BRIDGECOR STEEL BOX
STERLING RANCH ROAD- CO SPRINGS
COLORADO SPRINGS, CO

Response to comments
in green

BRIDGECOR STEEL BOX
38'-1" SPAN X 11'-11" RISE
STERLING RANCH ROAD- CO SPRINGS
COLORADO SPRINGS, CO

BRIDGE PLAN

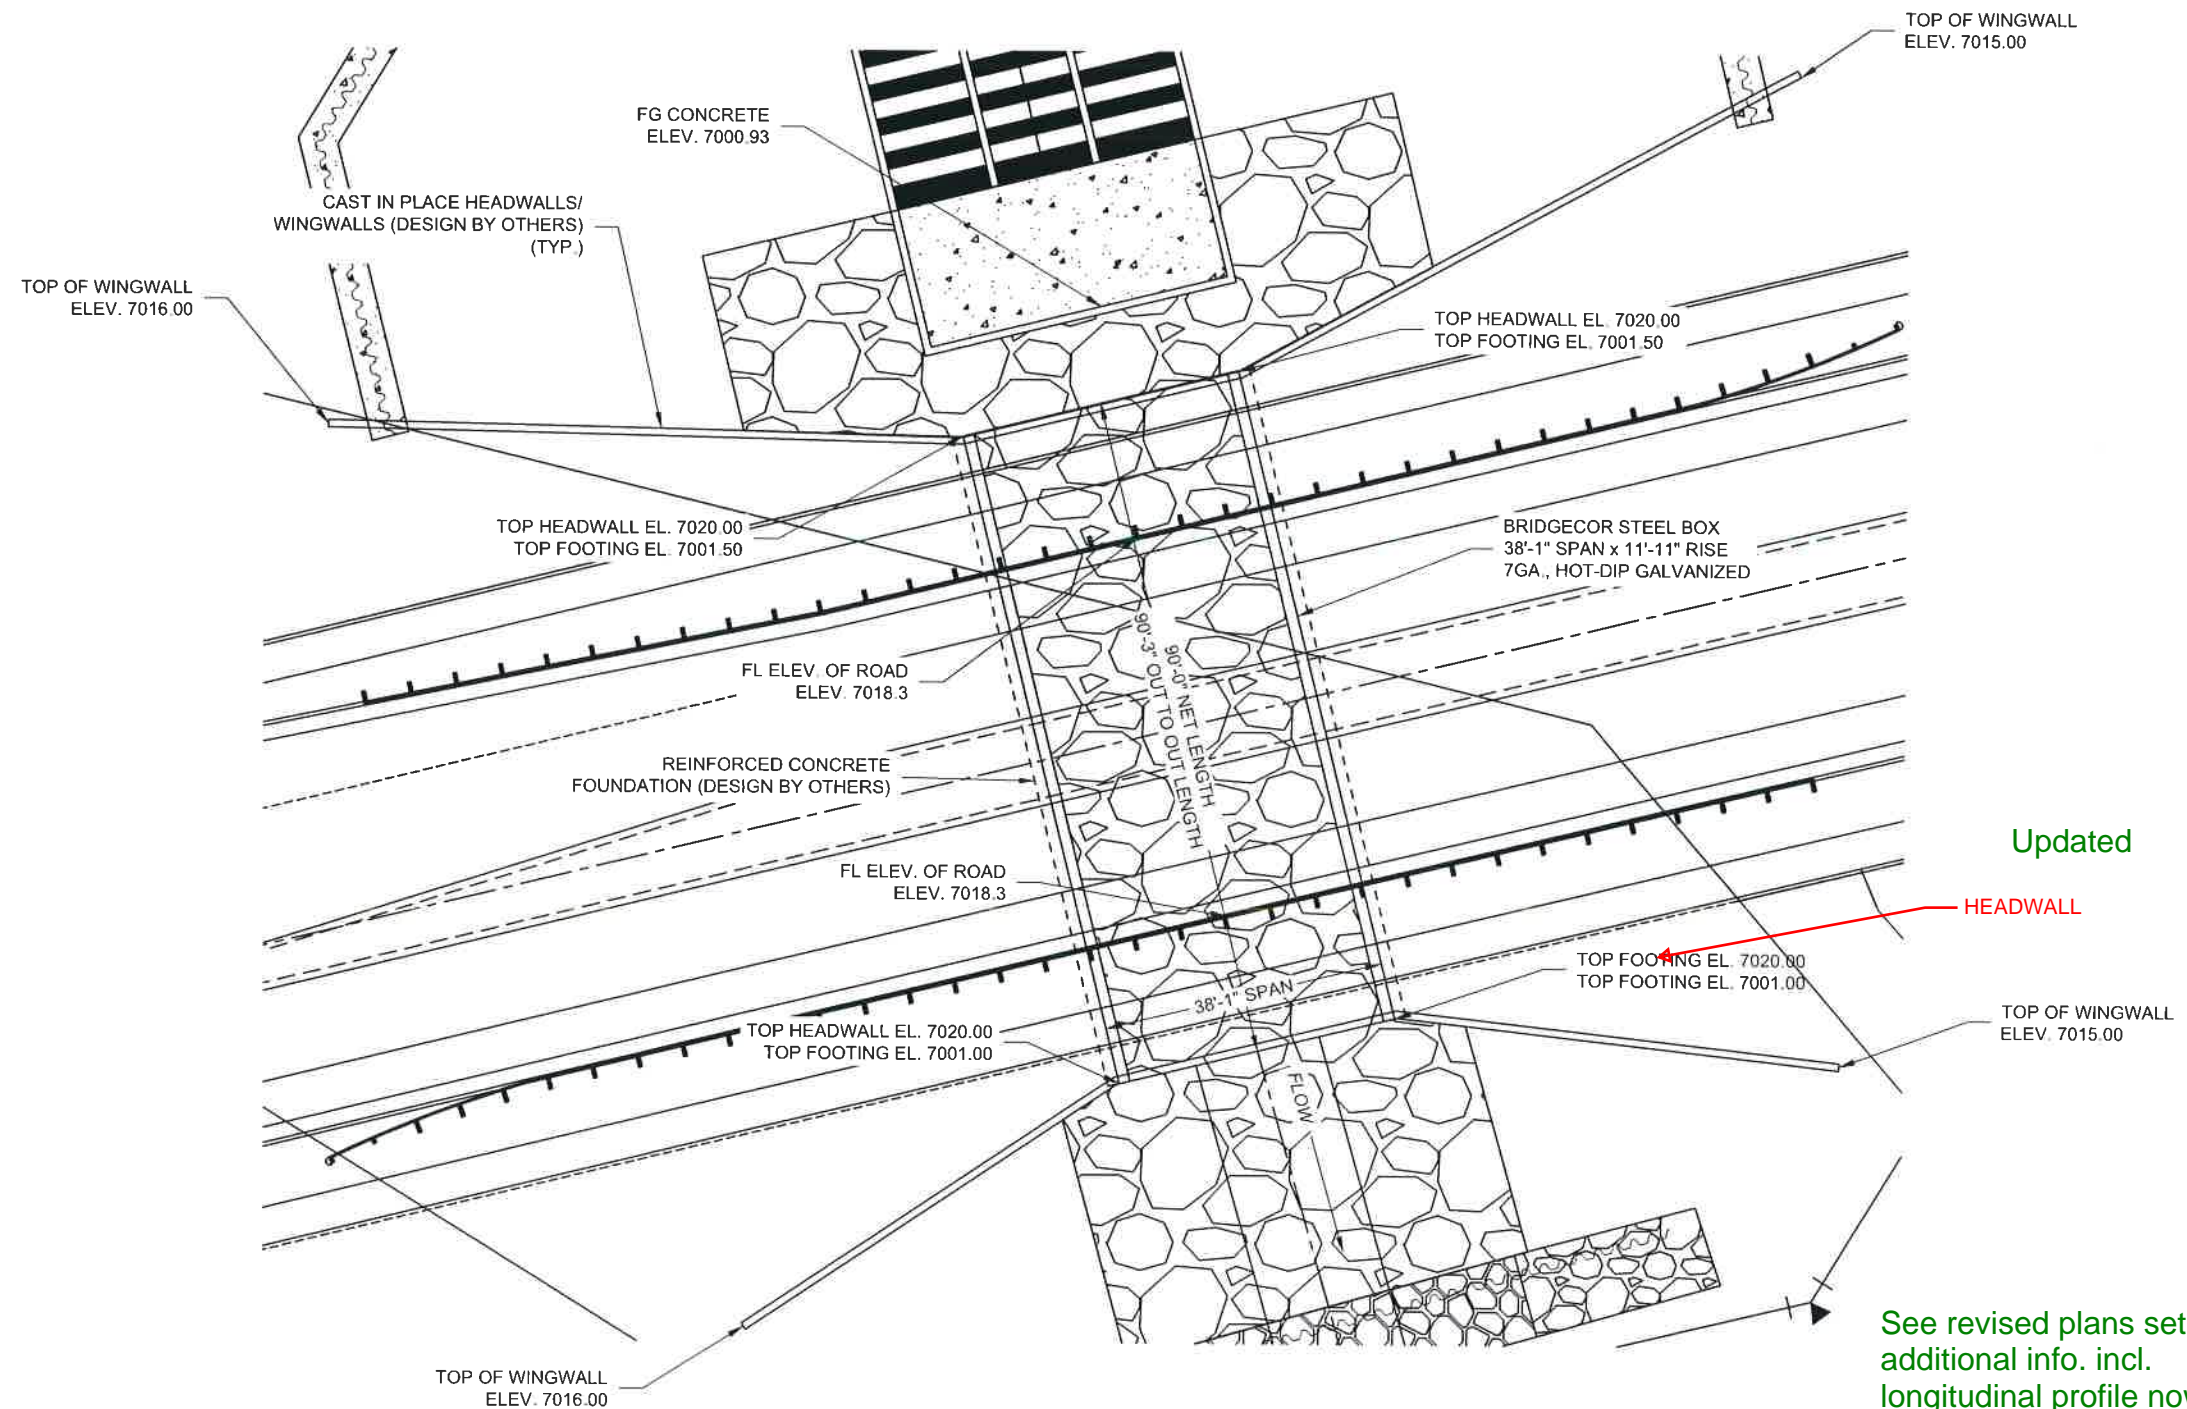
Provide plans, including all necessary appurtenances and elevations, cross-sections, and a longitudinal profile.

See revised plans set additional info. incl. longitudinal profile now included.

SECTION

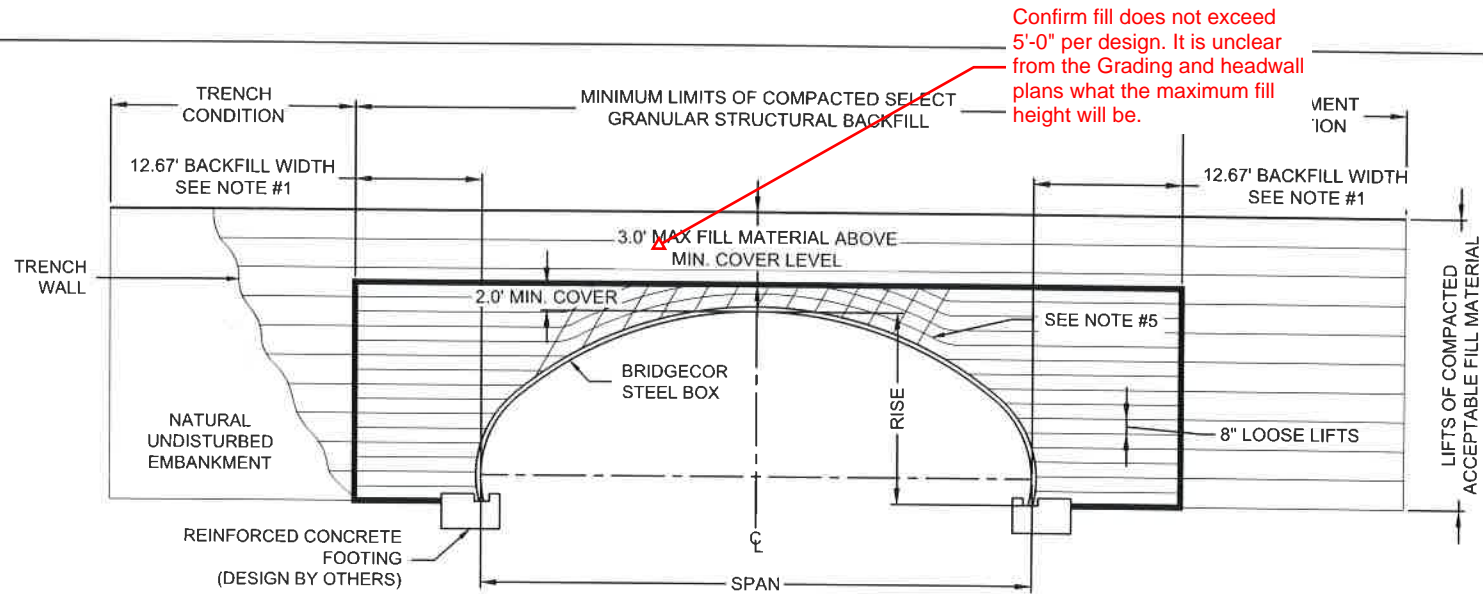
Confirm fill does not exceed 5'-0" per design. It is unclear from the Grading and headwall plans what the maximum fill height will be.

See revised plans. 5.75' is now the max. fill height design.

TYPICAL WINGWALL SECTION VIEW

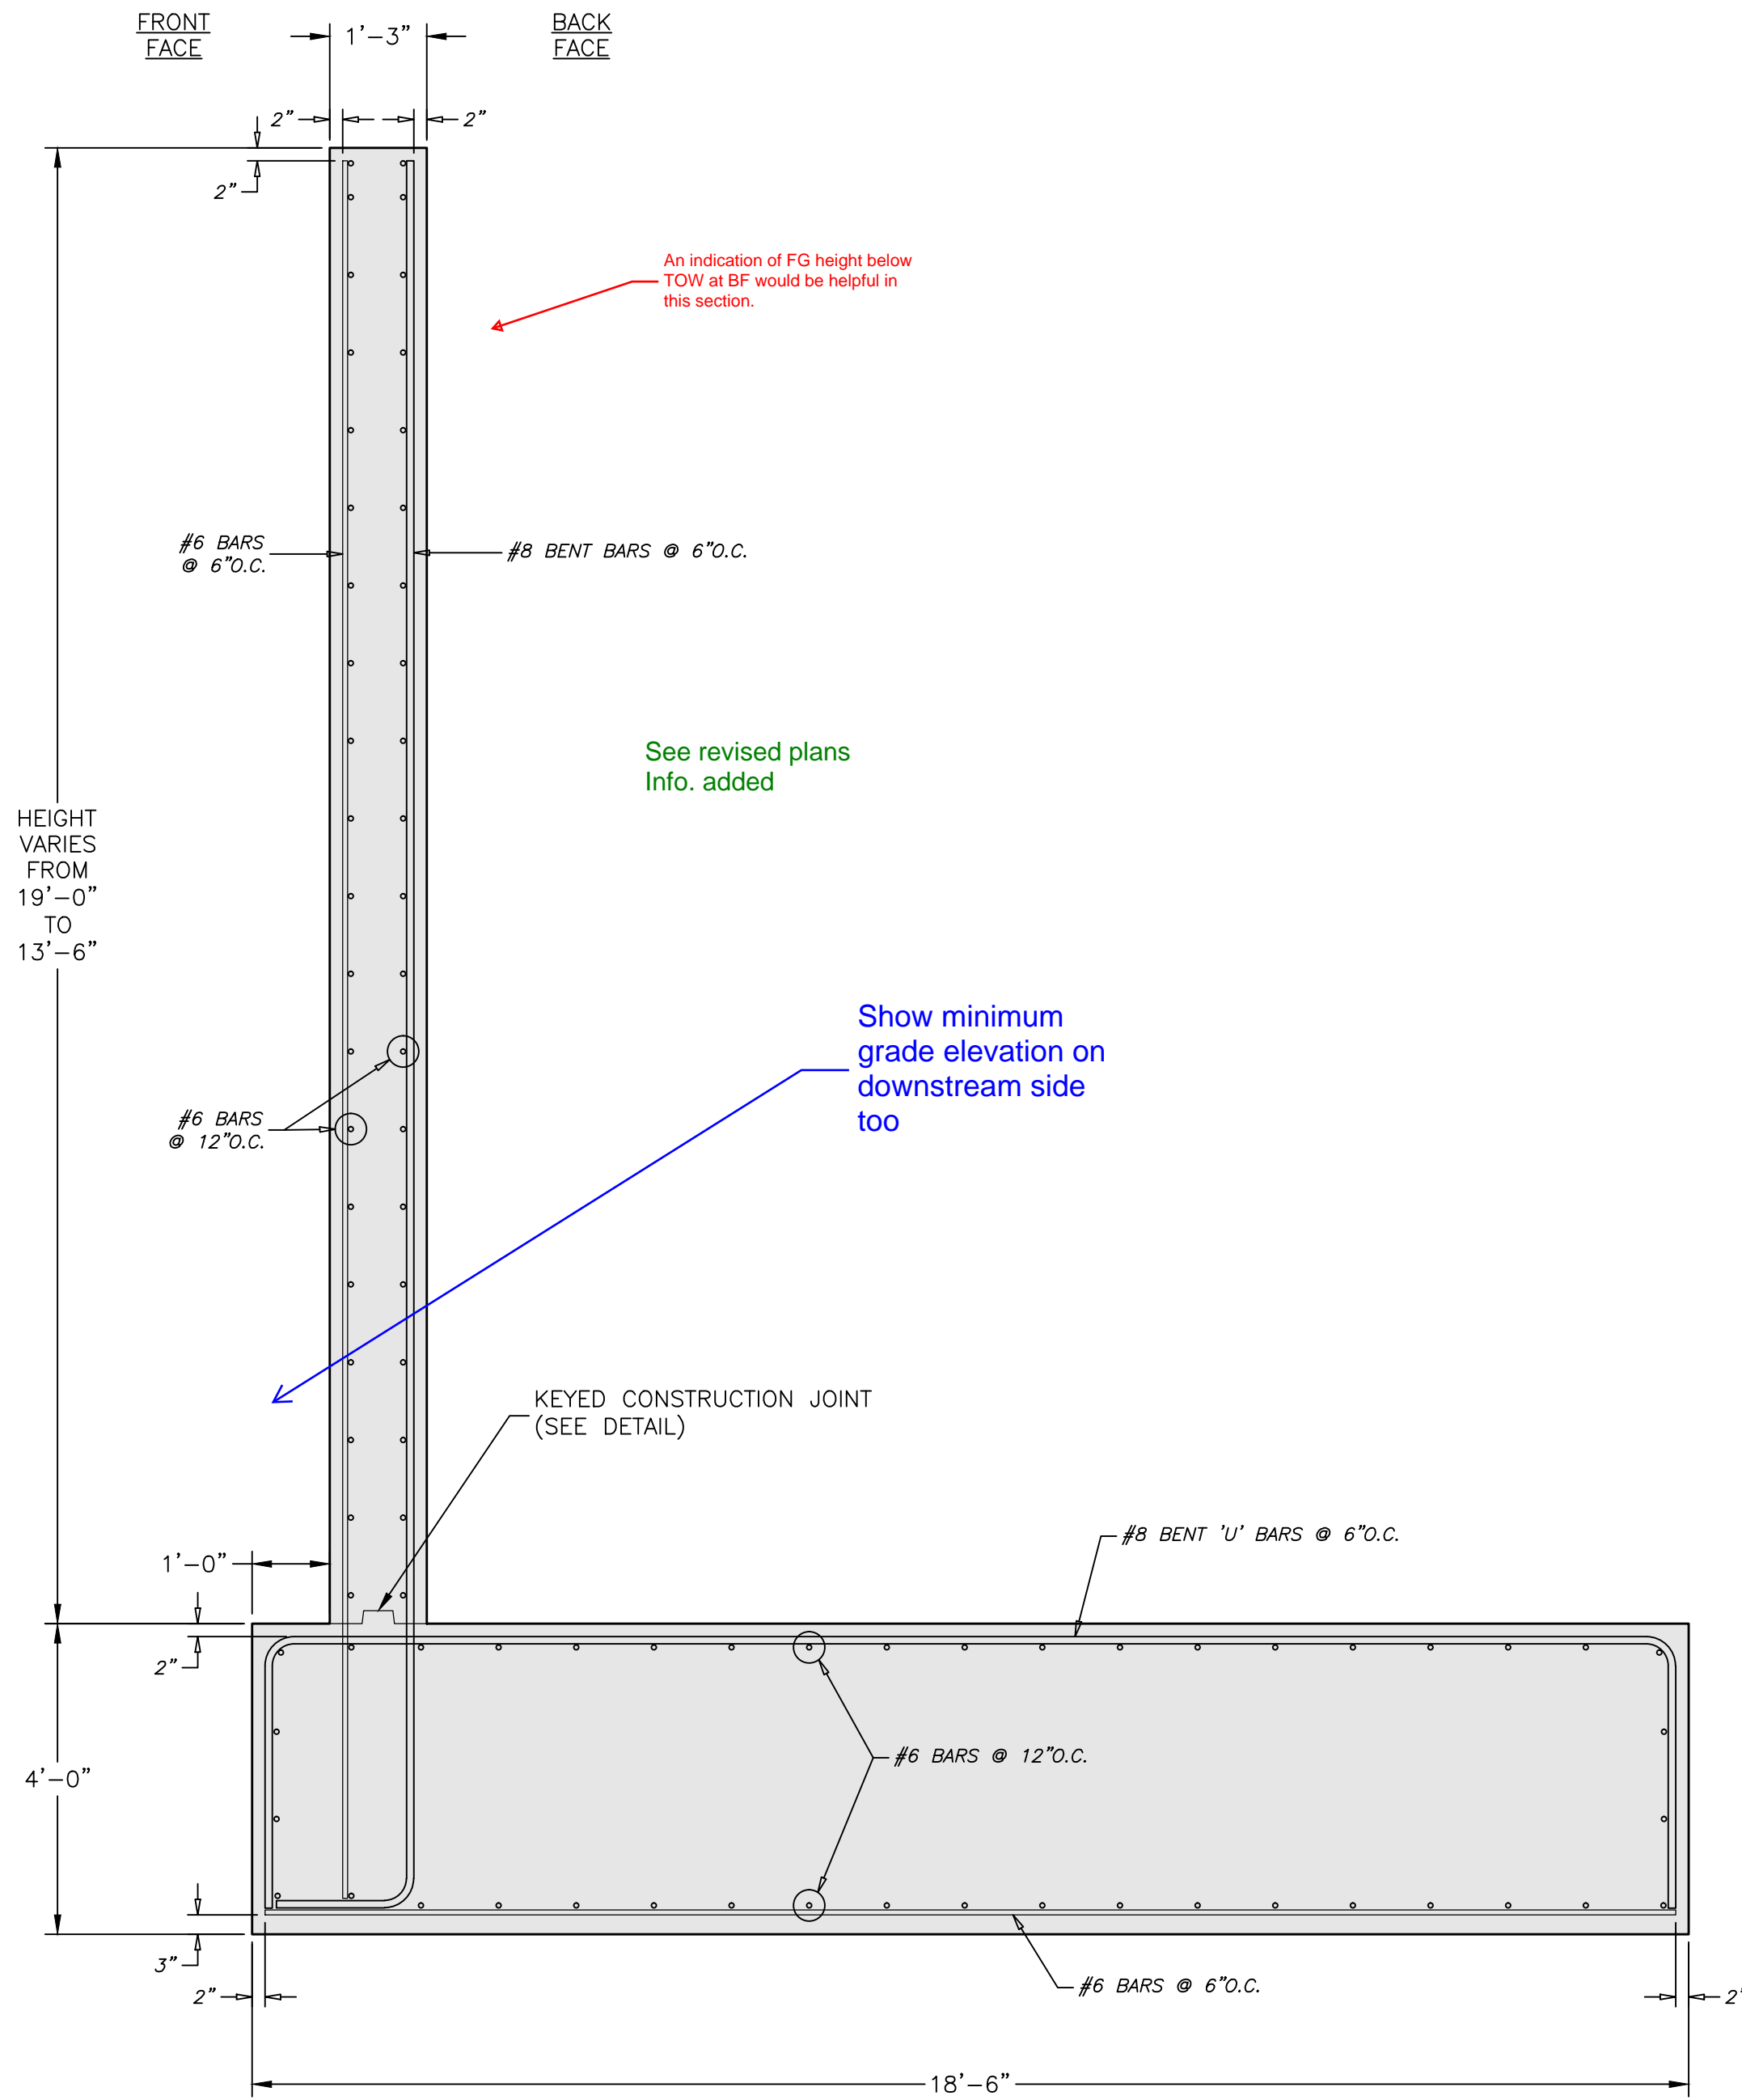
An indication of FG height below TOW at BF would be helpful in this section.

See revised plans Info. added

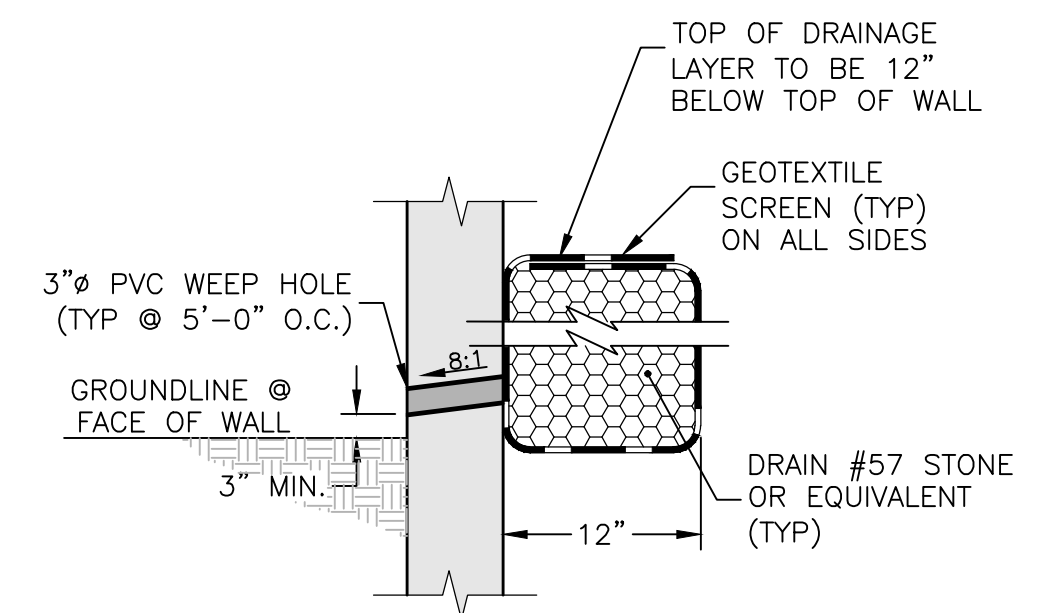
Show minimum grade elevation on downstream side too
